As part of our commitment to product innovation and performance, we've enhanced the F3 models (1/8 to 3 HP) by adding a B14 flange to the casing. This update increases mounting flexibility, making it easier to attach a torque arm across a range of applications and positions, while maintaining existing housing and mounting dimensions. The enhancement affects only one side of the gearbox, effective October 2018.

**AC INDUCTION MOTORS**

**Illustration of Changes**

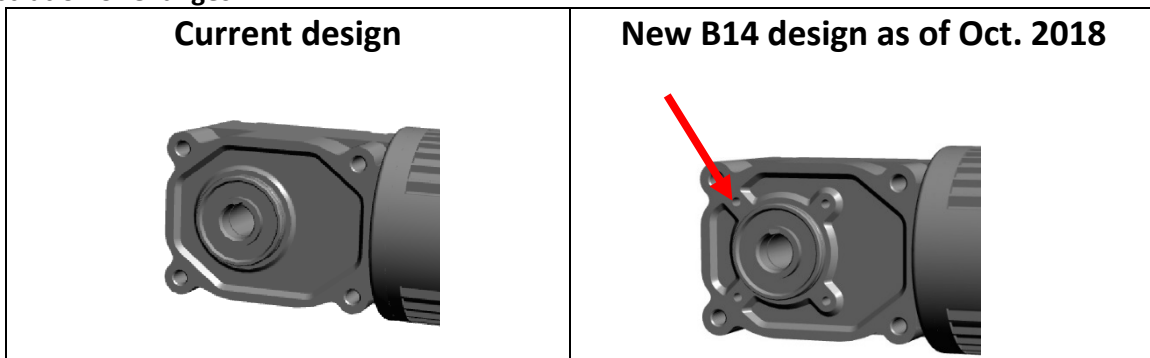
- **Models:** F3S Hollow Shaft and F3F Solid Shaft
- **Ratio:** 1/5~1/60
- **No Change to the following:** 3 HP with ratios of 1/40, 1/50 and 1/60
